Fw: Appeal of San Luis Obispo County Planning Commission Decision Certifying Final Environmental Impact Report for Loperena Minor Use Permit/Coastal Development Permit (DRC2005-00216) and Approval of Project

Re: Appeal of San Luis Obispo County Planning Commission Decision Certifying Final Environmental Impact Report for Loperena Minor Use Permit/Coastal Development Permit (DRC2005-00216) and Approval of Project

Letter from Haro, Kasunich and Associates, Inc.
"Review of Shoreline Engineering Bluff Study dated 9/28/14", dated December 2, 2014

Subject: Review of "Evaluation of Bluff Geometry Adjacent to Loperena Property"
prepared by Shoreline Engineering dated 9/28/14

FIGURE 1: CROSS SECTIONS SHOWING 1953 AND 2014 TOPOGRAPHIC PROFILES BY SHORELINE ENGINEERING, INC., & LOCATIONS OF FILL, 1953 BEACH, BOTTOM OF BLUFF AND TOP EDGE OF BLUFF BY HARO KASUNICH & ASSOCIATES, INC.

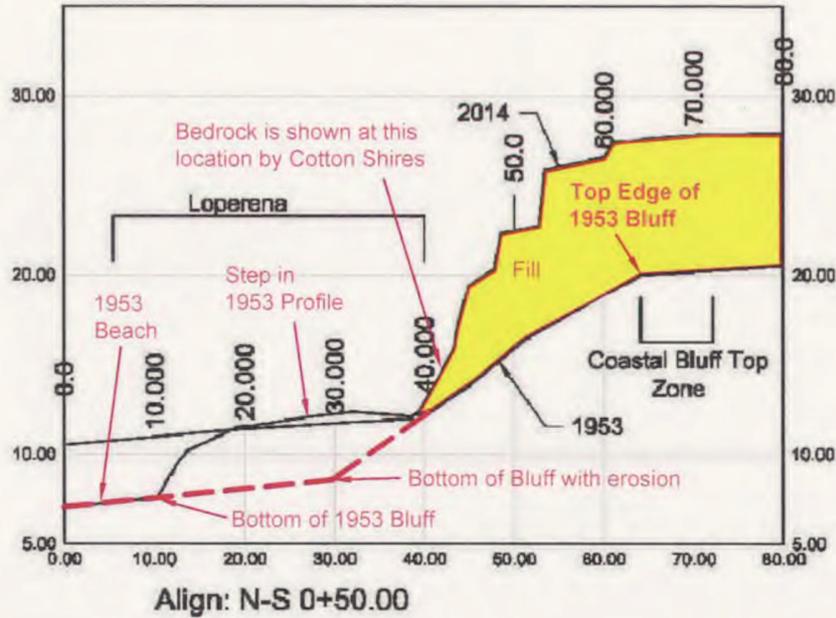
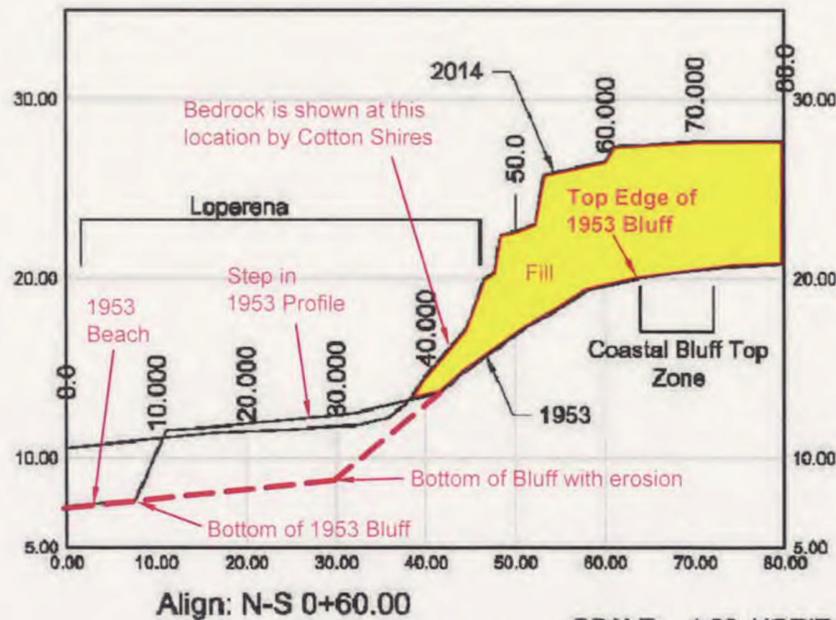
2. The cross sections associated with the 1953 and 2014 Topographic Surveys reveal approximately 7 feet of fill blanketing the upper portion of the cross sections in 2014, as shown on attached Figure 1. The 1953 cross sections show the pre-fill conditions and may be useful to determine the amount of natural vertical relief to confirm that the slope is a bluff. It is also helpful in determining the location of the natural bluff top edge, upon which the appropriate setback can be applied.
3. Shoreline states "No portion of the pre-development coastal bluff or the fluvial bluff is more than ten feet in height." We disagree.

We ask that you consider that the present 2014 bluff top area is at an elevation of +27 feet NAVD88, as shown on Figure 1. Using the current beach sand elevation of +12 feet NAVD88, that makes the current 2014 bluff face 15 feet high. In their analysis of wave runup, Geosoils Inc. projects that vertical erosion (beach scour) at the base of the present bluffs fronting the Loperena property will occur down to an elevation of + 3 feet NAVD88, approximately 9 feet below the existing elevation of the surface of the landward edge of the beach. Accounting for this scour and erosion, that makes the bluff face 24 feet high.

FIGURE 2: 2014 TOPOGRAPHIC MAP BY SHORELINE ENGINEERING, INC. SHOWING 1953 TOP EDGE OF BLUFF AS DEPICTED ON CROSS SECTIONS BY SHORELINE ENGINEERING, INC.

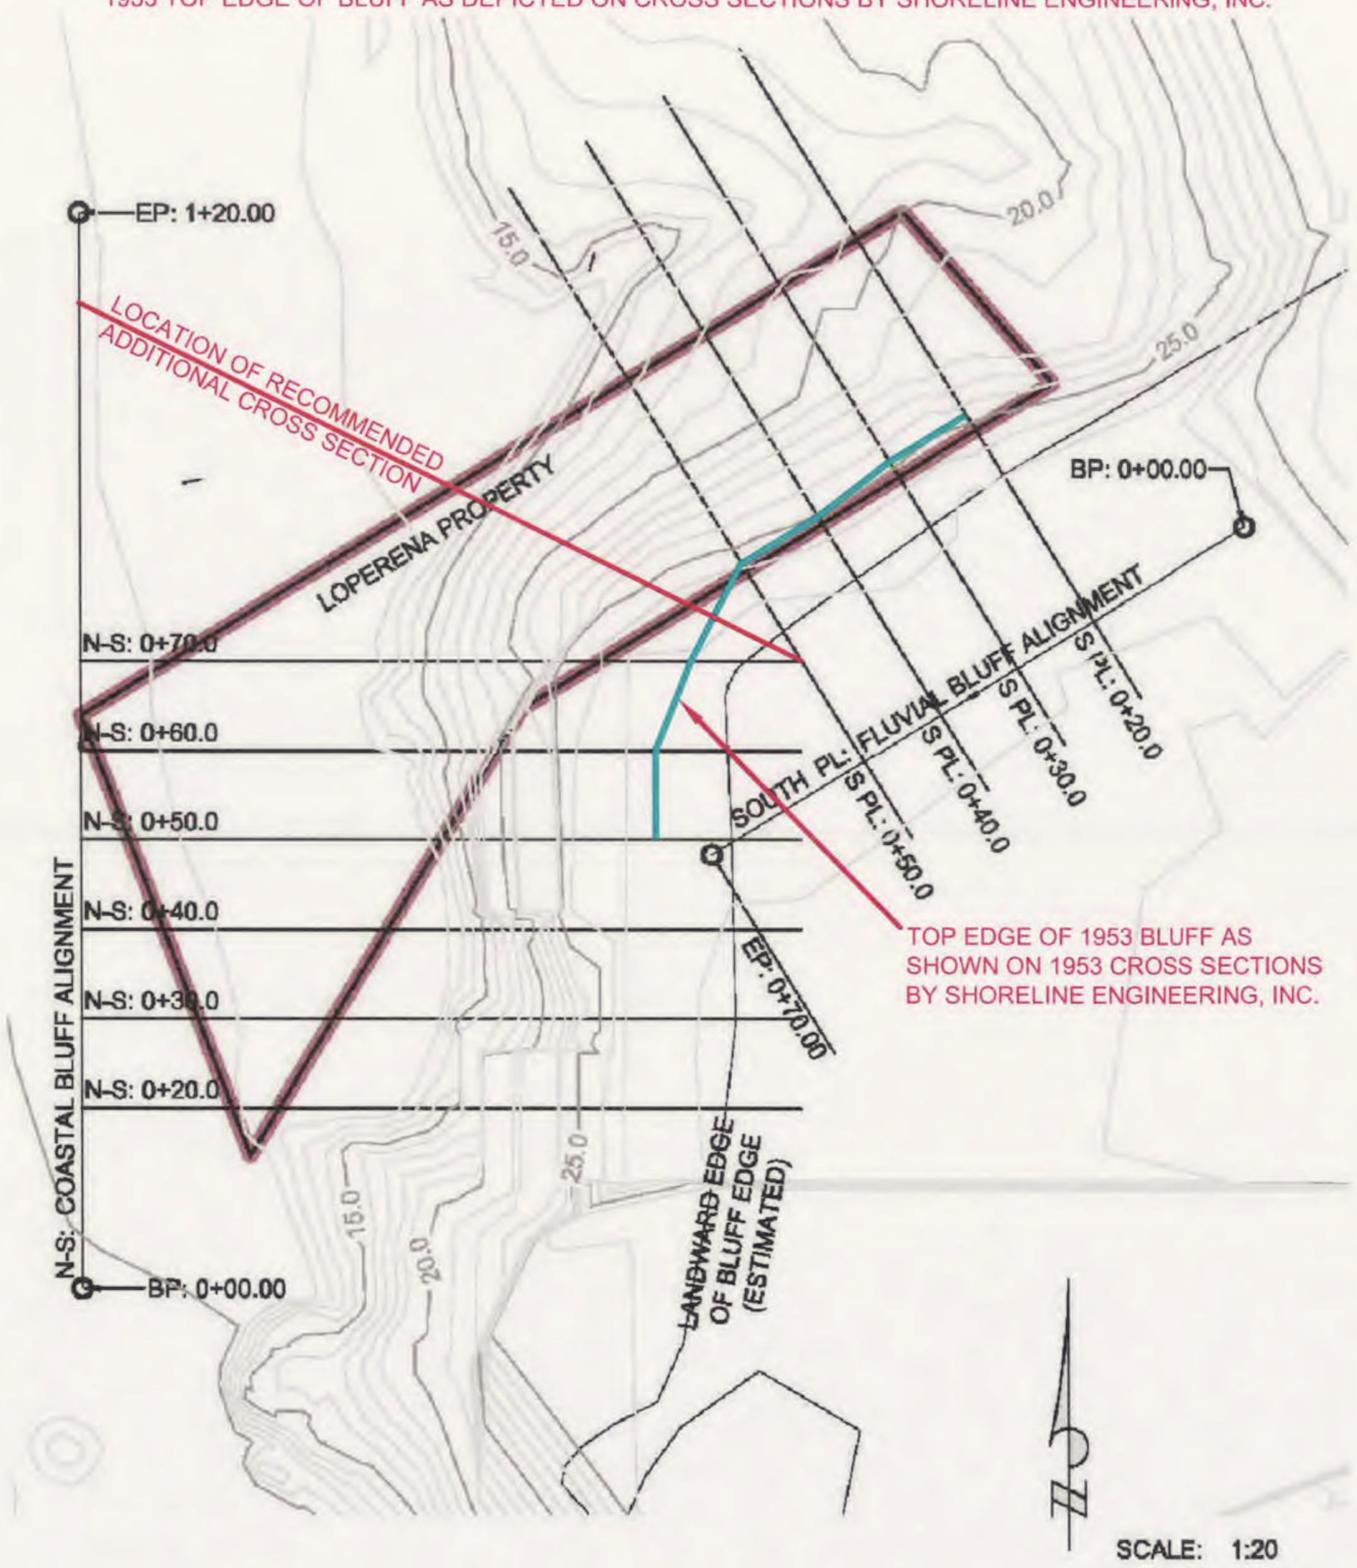
5. A large gap exists in the array of cross sections provided in the Shoreline Engineering Study; between N-S 0+70.00 and S PL 0+50.00. Figures 2 and 3 shows the

recommended location for an additional cross section, highlighted in pink, on the 2014 and 1953 Topographic Surveys from pages 4 and 5 of the Shoreline Engineering study, respectively. This is the area of the Loperena Property most exposed to future erosion and bluff recession and where the EIR geologist (Cotton Shires) has indicated that beach sand underlies a portion of the proposed building area footprint (see Cotton Shires Geologic Cross Section 1-1'). We recommend Shoreline Engineering prepare another profile in this area, where shown on attached Figures 2 and 3. Additionally we recommend erosion and wave run-up analysis be conducted using that profile as well as 2014 Profile N-S 0+70.00.

9. Based on the 1953 cross sections provided in the Shoreline Engineering study, we have mapped the top edge of the natural 1953 bluff on the 1953 and 2014 topographic maps provided Shoreline Engineering, see attached Figures 2 and 3. Most of the proposed development on the Loperena property is located below the top of the bluff and on the bluff face. SLO Coastal Plan Policies page 10-10, Policy 11 Development on Coastal Bluffs states "New development on bluff faces shall be limited to public access stairways and shoreline protection structures." Our understanding of Policy 11 is that a residential development is not allowed on the bluff face.

FIGURE 5 - 1965 CALTRANS AERIAL PHOTOGRAPH (APPROXIMATE SCALE: 1 INCH = 50 FEET)

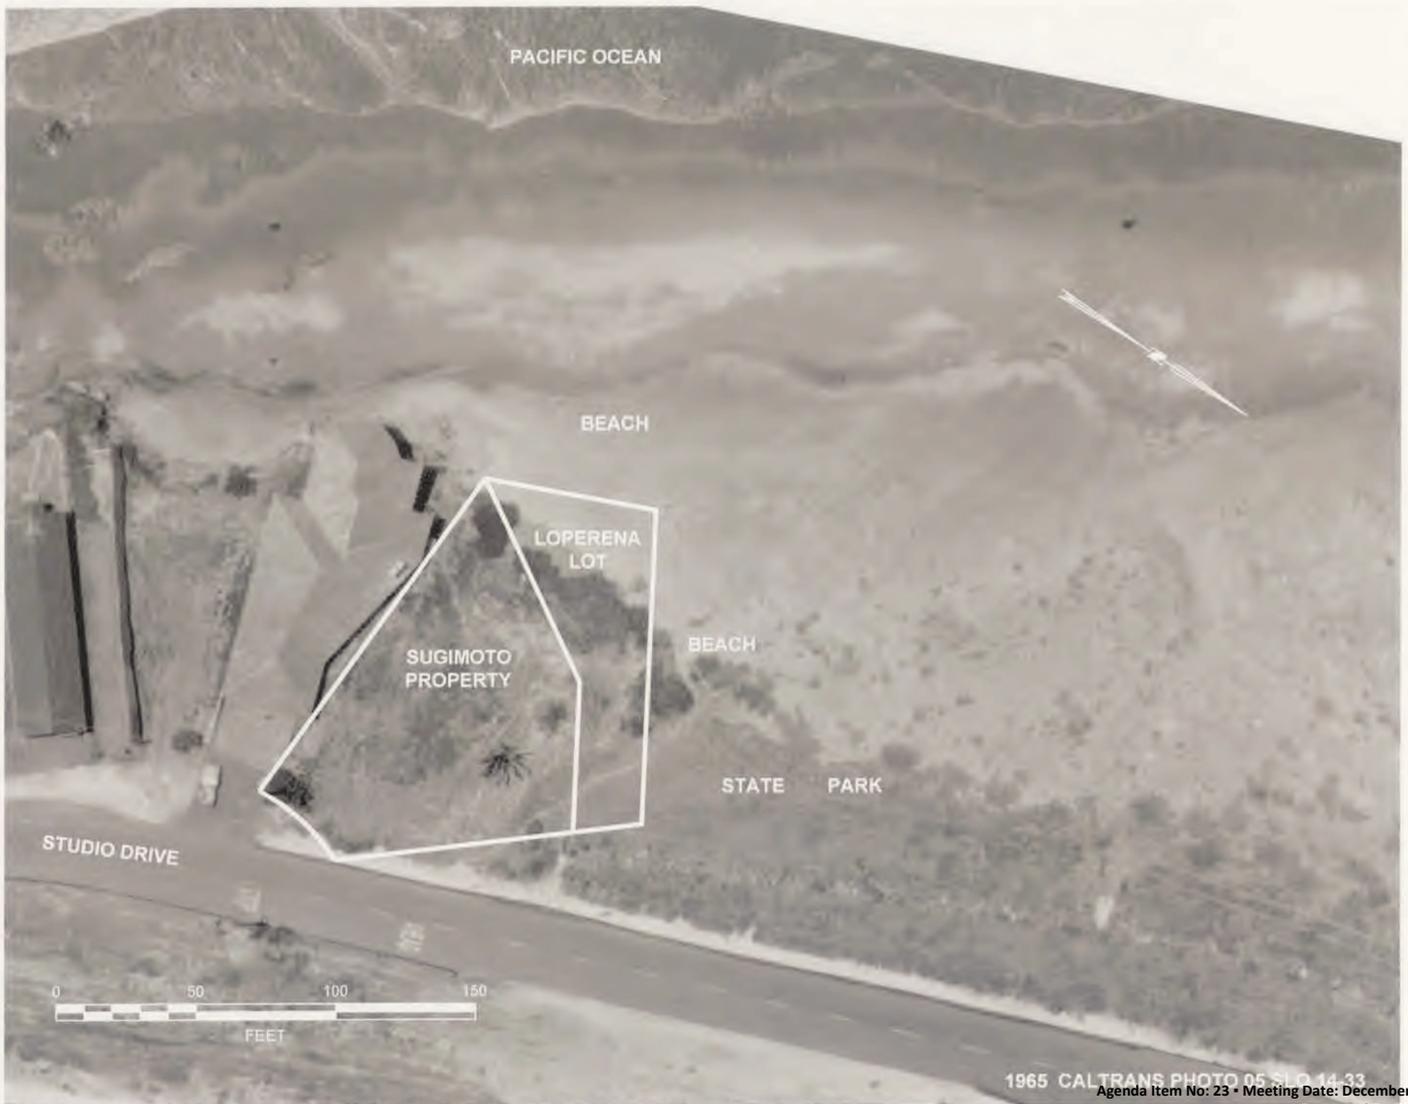
The Caltrans photographs used in the Shoreline Engineering study provide additional evidence that the toe of the bluff has historically been subject to marine erosion; and therefore this bluff is a coastal bluff. Figures 5 and 6 (attached) are the Caltrans photographs, which show evidence of recent erosion on both the Sugimoto and Loperena properties. The evidence of erosion includes areas of barren rock and areas stripped of vegetation. Evidence of ocean wave runup onto the Loperena property is visible in both Figures 5 and 6, and on Figure 8 (taken before the construction of Highway 1) and Figure 9 (taken after the construction of Highway 1 which involved placement of fill on the Loperena property). Our submittal "Review of Draft EIR Comments" dated 1 August 2013 photographically documents wave runup reaching and impacting the bluff face on the Loperena property during the last few years.

These photos clearly depict the Loperena property being subject to marine erosion (from ocean wave impact) in both 1953 and 1965. It is apparent on the 1953 Caltrans photo (Figures 6 and 9) that the Loperena property was being bombarded by ocean wave impact and subject to marine erosion. On the 1953 photograph, darker colored sand that appears to be wet from wave run-up exists close to the base of the bluff and little if any dry beach area exists seaward of the Loperena lot. Erosion has exposed barren bedrock just downcoast of the Loperena lot and has resulted in an erosional scarp extending across the Loperena lot and the area immediately upcoast.

FIGURE 8 - 1965 CALTRANS AERIAL PHOTOGRAPH (APPROXIMATE SCALE: 1 INCH = 200 FEET)

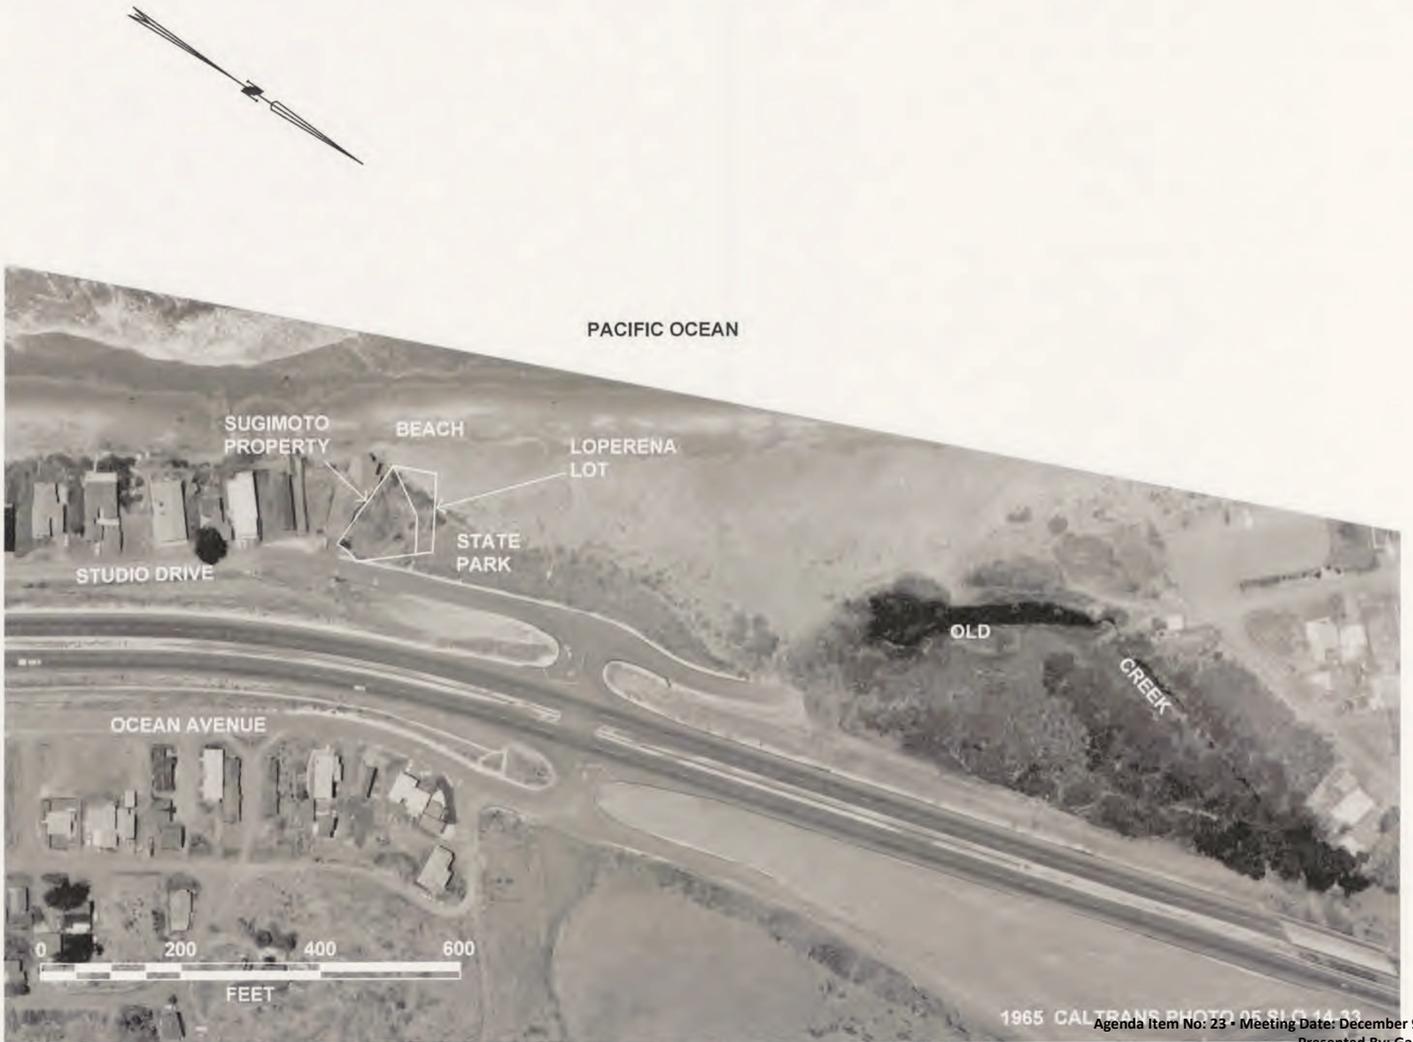
10. We have put the approximate property boundaries on a 2013 Google Earth image, 1965 Caltrans aerial photo and on a 1953 Caltrans aerial photo and have made prints at

approximately 1 inch = 50 feet (Figures 4, 5 and 6) and 1 inch = 200 feet (Figures 7, 8 and 9). See attached.

FIGURE 1: CROSS SECTIONS SHOWING 1953 AND 2014 TOPOGRAPHIC PROFILES BY SHORELINE ENGINEERING, INC., & LOCATIONS OF FILL, 1953 BEACH, BOTTOM OF BLUFF AND TOP EDGE OF BLUFF BY HARO KASUNICH & ASSOCIATES, INC.

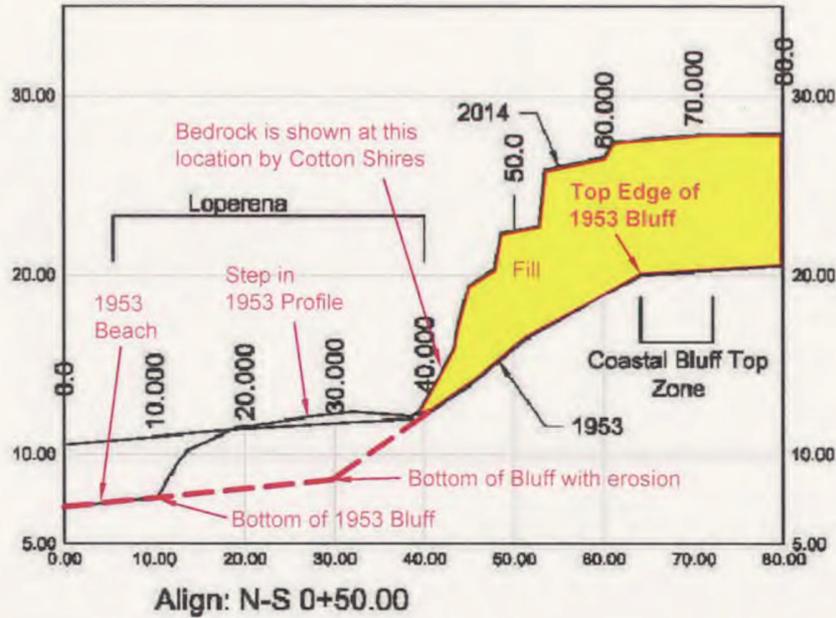
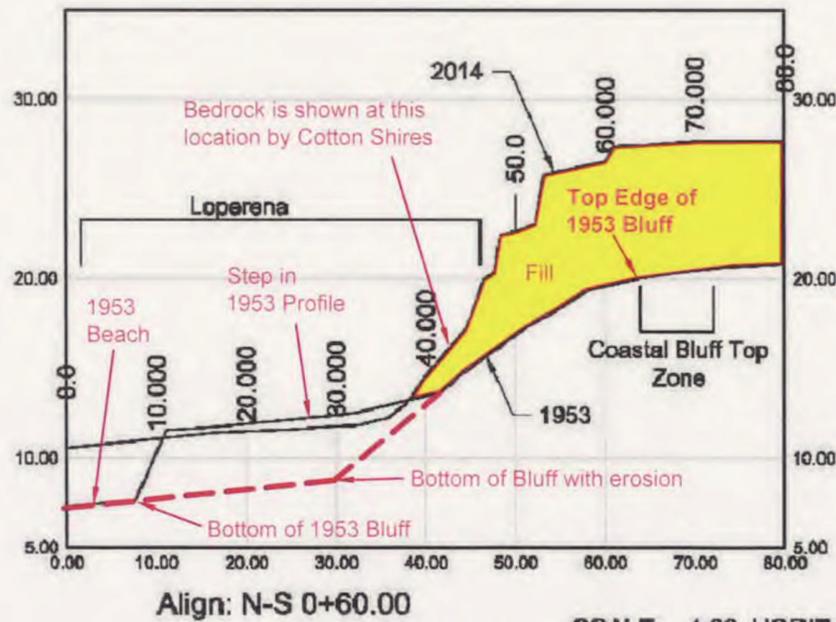
2. The cross sections associated with the 1953 and 2014 Topographic Surveys reveal approximately 7 feet of fill blanketing the upper portion of the cross sections in 2014, as shown on attached Figure 1. The 1953 cross sections show the pre-fill conditions and may be useful to determine the amount of natural vertical relief to confirm that the slope is a bluff. It is also helpful in determining the location of the natural bluff top edge, upon which the appropriate setback can be applied.
3. Shoreline states "No portion of the pre-development coastal bluff or the fluvial bluff is more than ten feet in height." We disagree.

We ask that you consider that the present 2014 bluff top area is at an elevation of +27 feet NAVD88, as shown on Figure 1. Using the current beach sand elevation of +12 feet NAVD88, that makes the current 2014 bluff face 15 feet high. In their analysis of wave runup, Geosoils Inc. projects that vertical erosion (beach scour) at the base of the present bluffs fronting the Loperena property will occur down to an elevation of + 3 feet NAVD88, approximately 9 feet below the existing elevation of the surface of the landward edge of the beach. Accounting for this scour and erosion, that makes the bluff face 24 feet high.

FIGURE 2: 2014 TOPOGRAPHIC MAP BY SHORELINE ENGINEERING, INC. SHOWING 1953 TOP EDGE OF BLUFF AS DEPICTED ON CROSS SECTIONS BY SHORELINE ENGINEERING, INC.

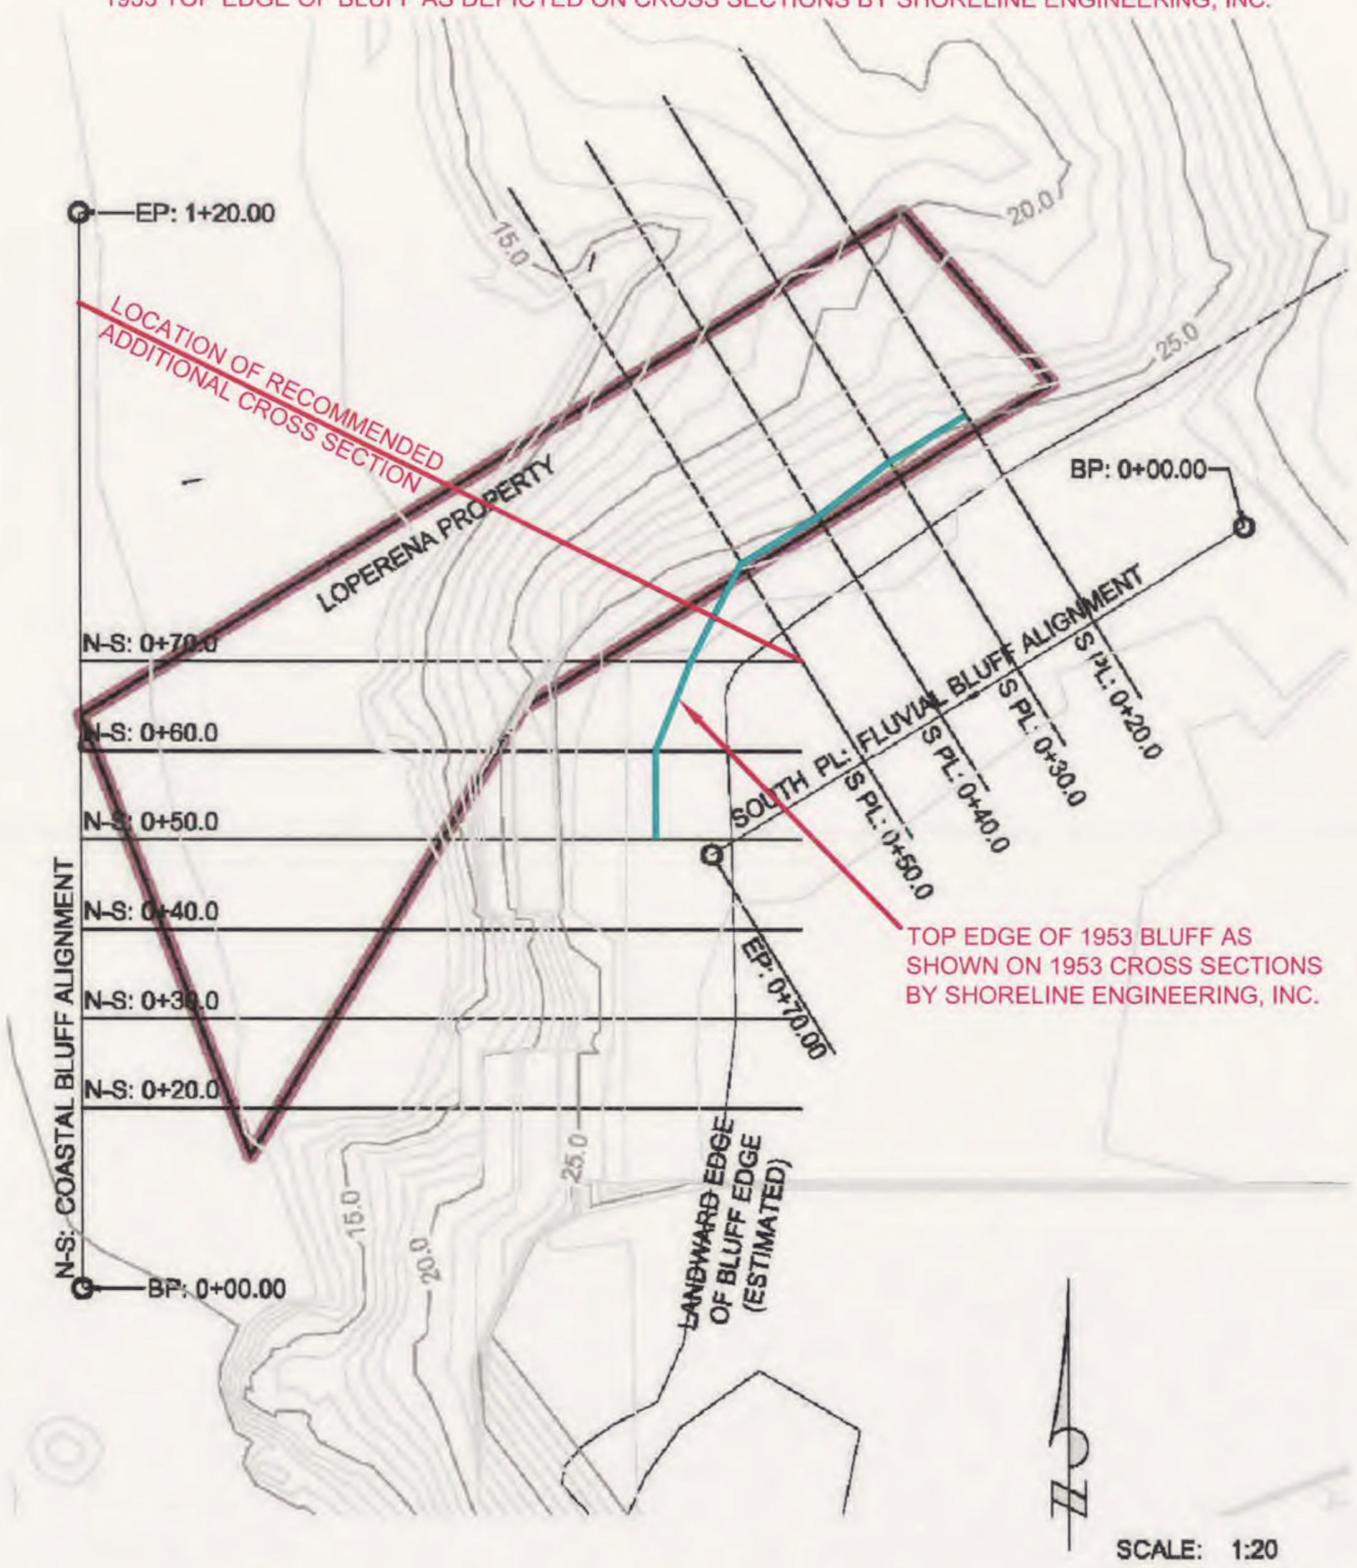
9. Based on the 1953 cross sections provided in the Shoreline Engineering study, we have mapped the top edge of the natural 1953 bluff on the 1953 and 2014 topographic maps provided Shoreline Engineering, see attached Figures 2 and 3. Most of the proposed development on the Loperena property is located below the top of the bluff and on the bluff face. SLO Coastal Plan Policies page 10-10, Policy 11 Development on Coastal Bluffs states "New development on bluff faces shall be limited to public access stairways and shoreline protection structures." Our understanding of Policy 11 is that a residential development is not allowed on the bluff face.
